**ADDENDUM NO. 6**

**BREWSTER CENTRAL SCHOOL DISTRICT  
BREWSTER HIGH SCHOOL  
SECURITY VESTIBULE, SYNTHETIC FIELD AND RELATED WORK**

DATE: May 13, 2024

This Addendum consists of two (2) pages plus Sketch SK-15.

05-13-2024	BID ADDENDUM #6
DATE	ISSUED TO
SCALE:	AS NOTED
FILE NO. <b>23505.01</b>	DRAWING NO. <b>SK-15</b>

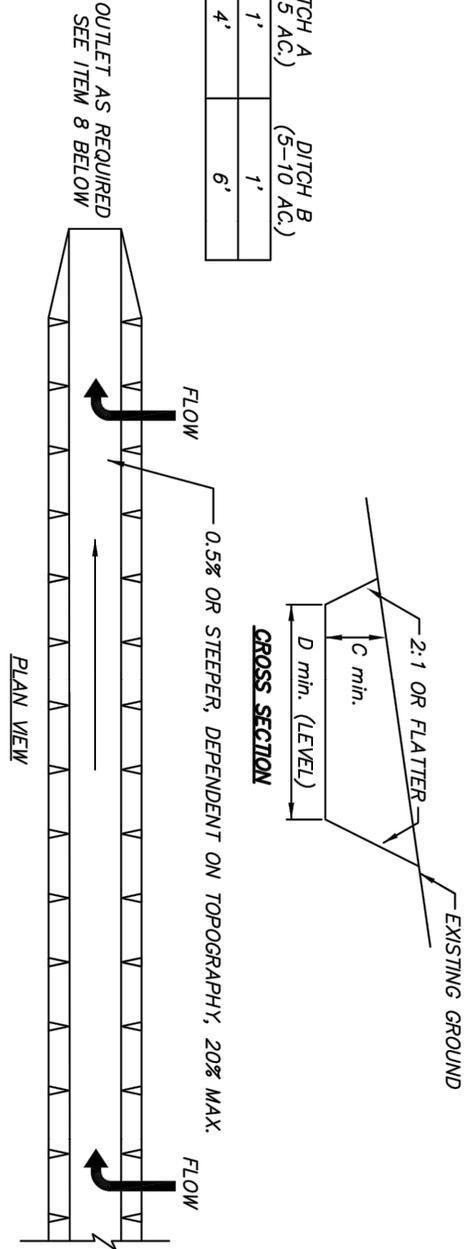
**ADD** Temporary Bypass Swale detail as indicated on Sketch SK-15 attached to this addendum.
